**Final Report**

**Gladstone Area Water Board:  
Investigation of Contingent Water  
Supply Strategy Pricing Practices**

**Part B**

**December 2008**

**Figure 2.1 Awoonga Dam Inflows – 1938-2007, five-year moving average**

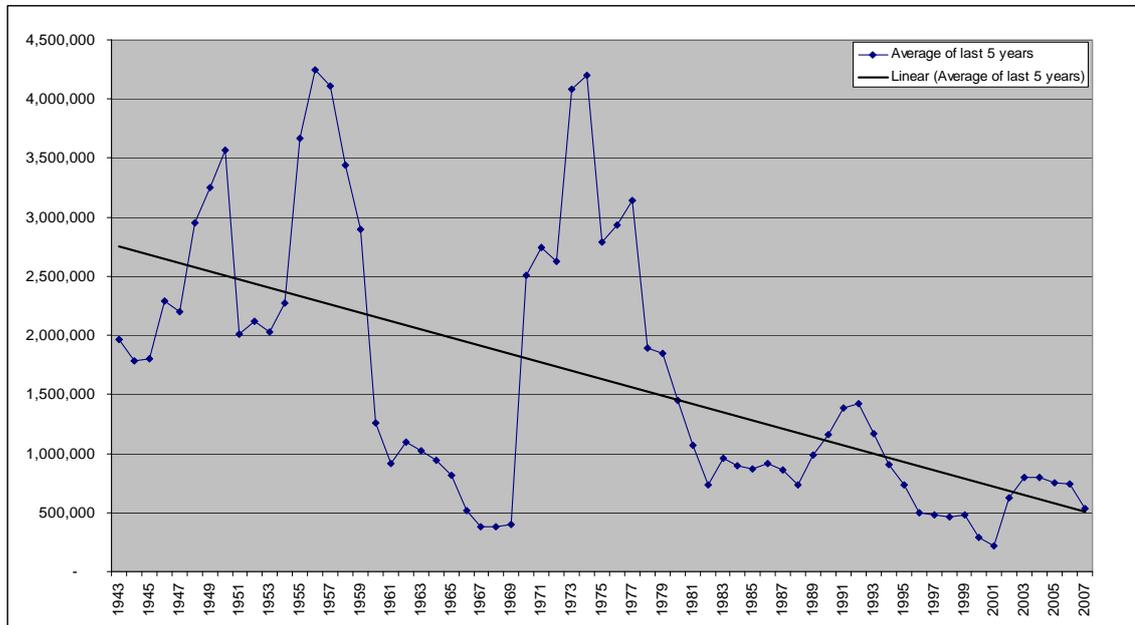
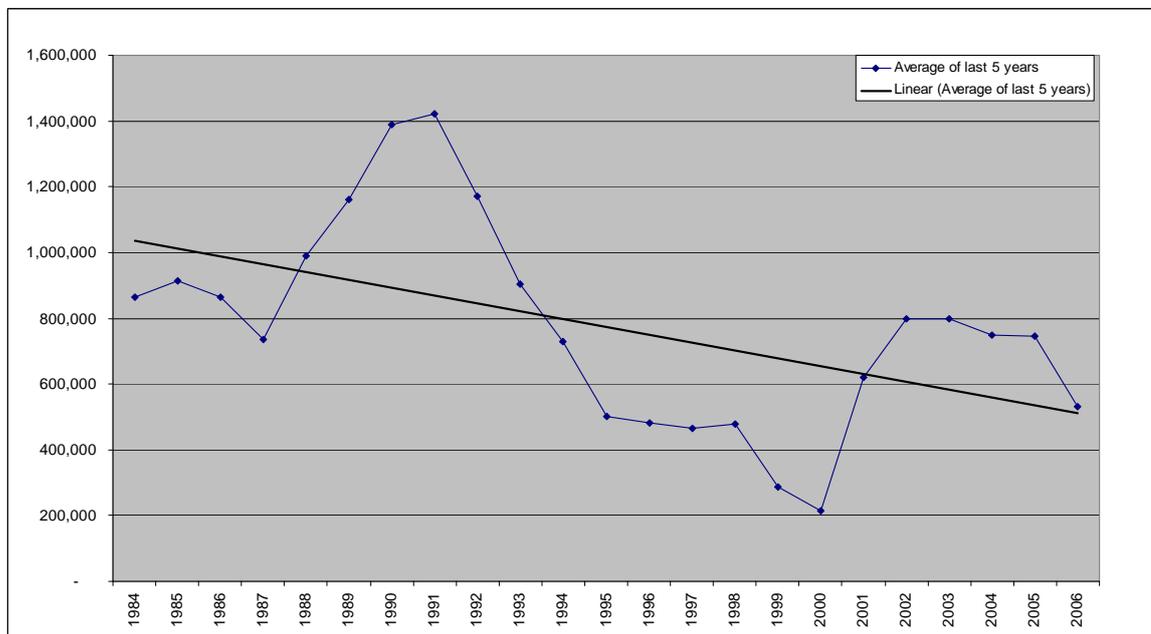
The Authority noted Synergies’ concerns about climate change impacts on future inflows given the limited history currently available to GAWB. In addition, it was noted that the QWC has adopted a climate change scenario for SEQ based on a mid-range estimate of a 10% reduction in available yield from current storages as compared to already reduced levels. The Authority therefore concluded that it was prudent to account for the risk of long term variations in rainfall

patterns that could be due in part or in whole to climate change. In general, this analysis strengthened the case for a shorter more conservative time period for averaging inflows.

**Figure 2.3 Lake Awoonga Storage Projections (three-year and four-year one in 200 years Worst Average Inflow Assumptions, with 10% restrictions under the DMP)<sup>1</sup>**

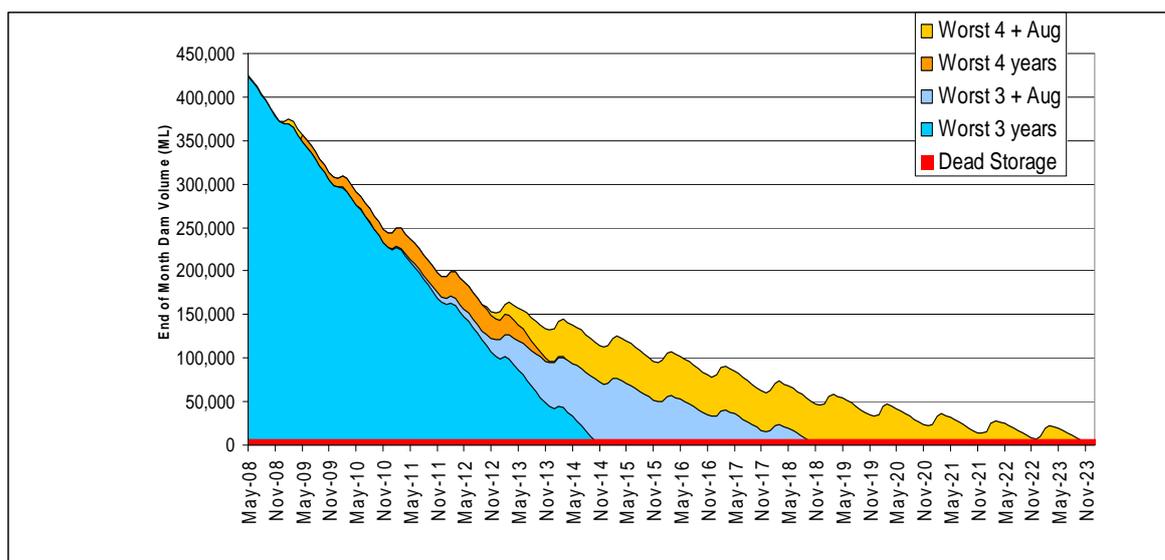
- (c) the Authority considers that the difference in the scenarios, that is between 23,633ML and 33,746ML is not minor. As noted by customers, at least one scenario (the four year stochastic worst average) would defer augmentation by almost two years and this would increase the possibility that additional rainfall would remove the need for augmentation that would have already occurred under more conservative scenarios; and

- (d) the Authority's analysis is not intended to imply that there is a single correct value for the inflow assumption. However, in view of the Authority's modelling and customer comments, GAWB's current inflow assumption is considered to be too conservative for the purposes of triggering augmentation.
